ADVISORY COMMITTEE ON REACTOR SAFEGUARDS
COMBINED DHRS / ABWR SUBCOMMITTEE MEETING MINUTES:
REVIEW OF ITAAC FOR SELECTED ABWR PLANT SYSTEMS
AUGUST 5, 1992
BETHESDA, MARYLAND

The purpose of the meeting was for the combined Subcommittee to review a selected set of ITAAC (Inspections, Tests, Analyses, and Acceptance Criteria) that support the GE Nuclear Energy (GE) ABWR design certification effort.

Figure 2.2.4 Standby Liquid Control System (Standby Mode)

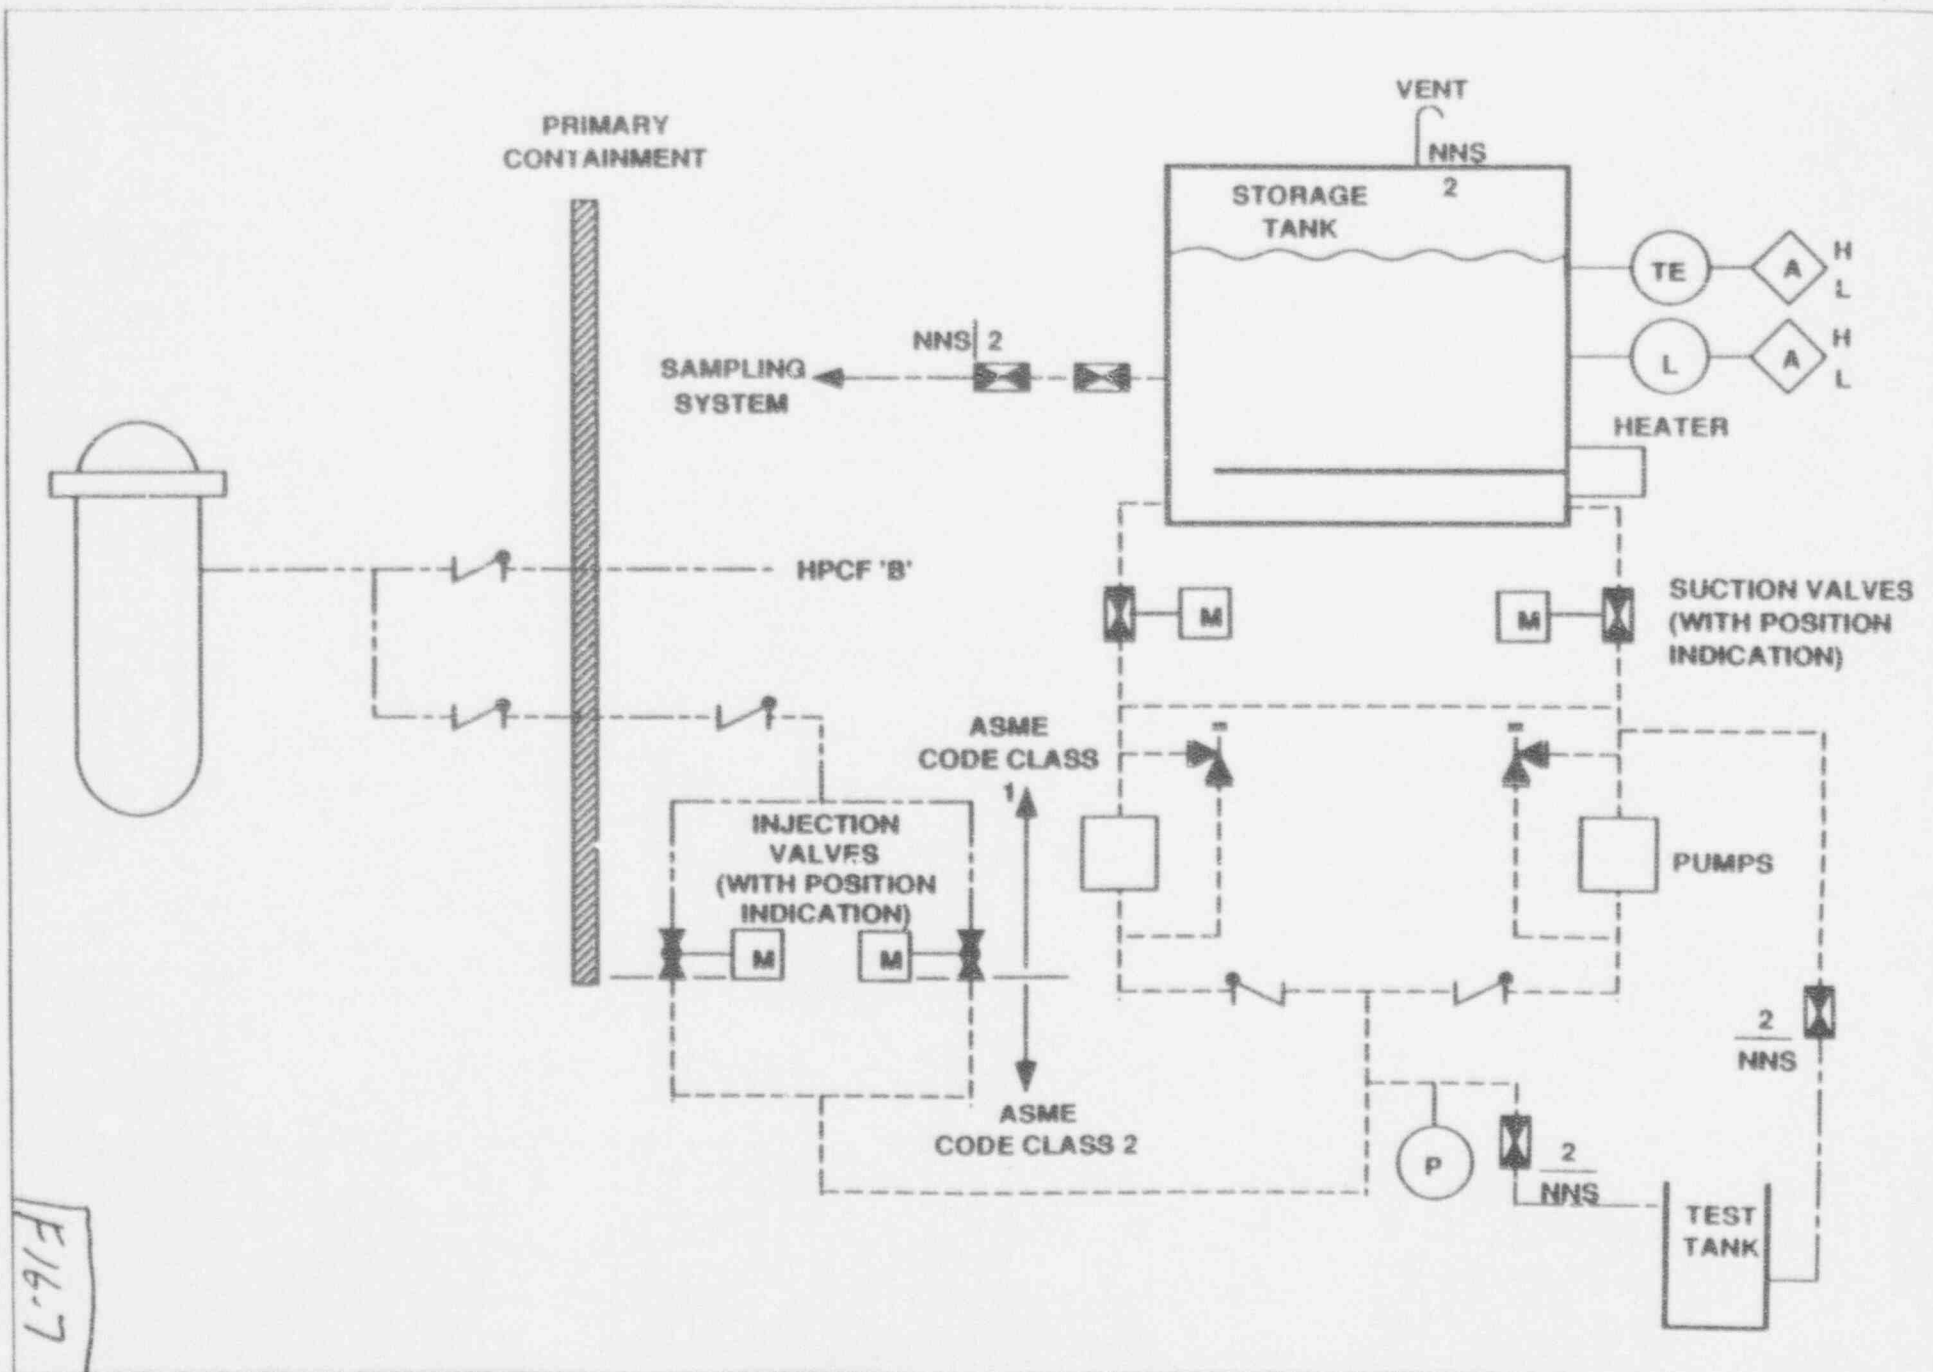
- Standby Liquid Control System - Figures 5-7 detail the specific content of this ITAAC. Extensive comment was provided on the associated text. The Subcommittee agreed that the scope and form of this ITAAC appears acceptable, but the content is in need of a lot of work. Mr. Ward questioned the lack of materials requirements. Dr. Shewmon indicated that GE
